**Seward Airport Improvements  
Final Environmental Assessment  
Errata Sheet**

**Summary of Changes**

Seward Airport Improvements  
 Environmental Assessment  
 Proposed Action

Date: 12/17/2018      Figure: 2

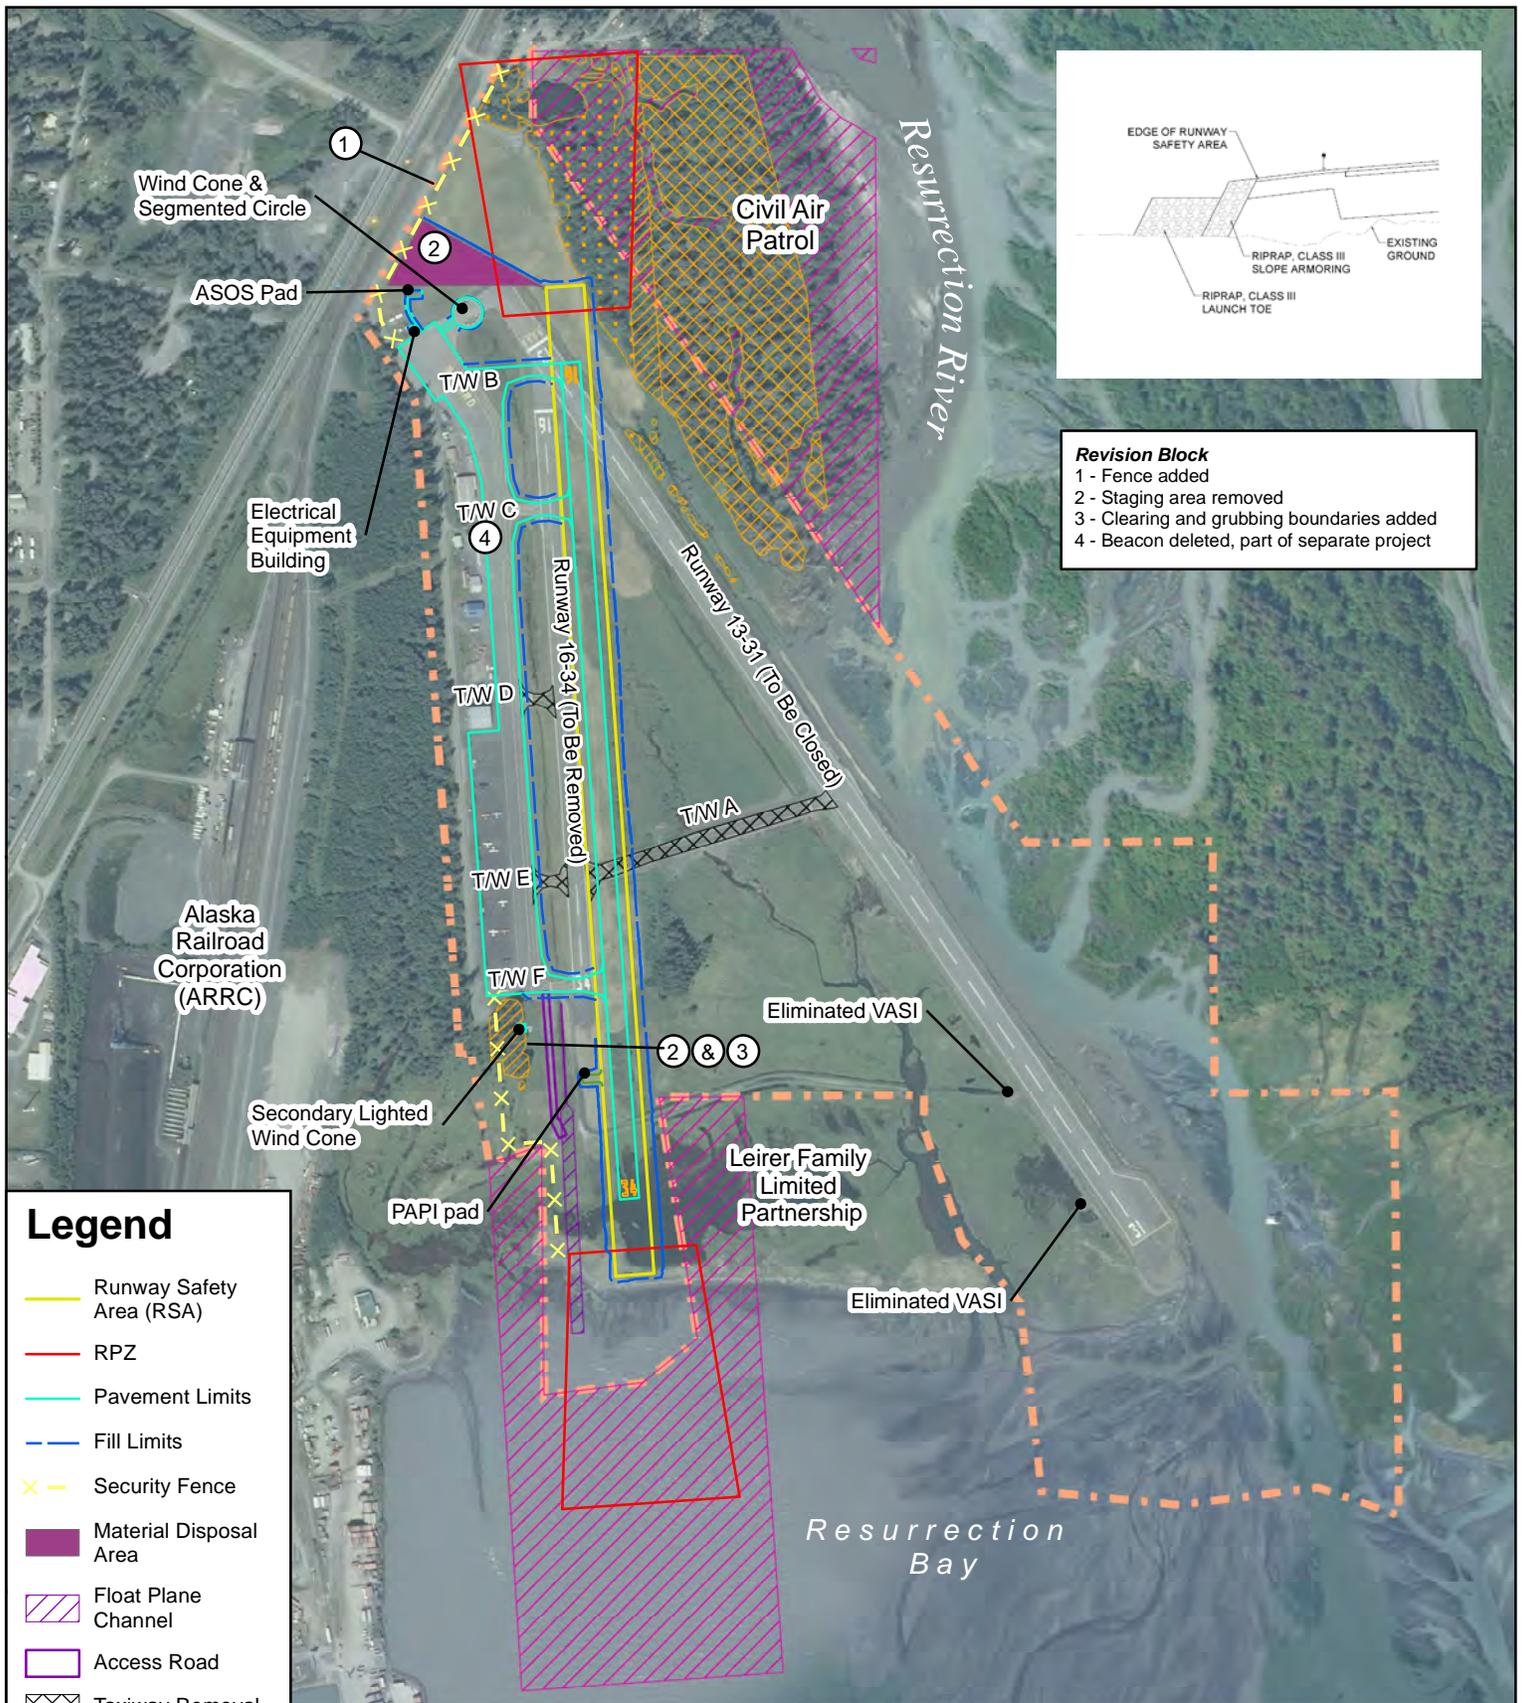
- Figure 2. Proposed Action (see attached)
  - 1) Fencing added to north airport boundary,
  - 2) staging area removed,
  - 3) clearing & grubbing boundaries added, and
  - 4) beacon deleted, this will be completed under a separate project.
- Page 6, Section 3.3 (see below) – language modified
- Page 9, Table 1, Cumulative Impacts (see below) – change language to match Table 20
- Figures 3-9. - updated to reflect changes in Figure 2.

**Revision Block**  
 1 - Fence added  
 2 - Staging area removed  
 3 - Clearing and grubbing boundaries added  
 4 - Beacon deleted, part of separate project
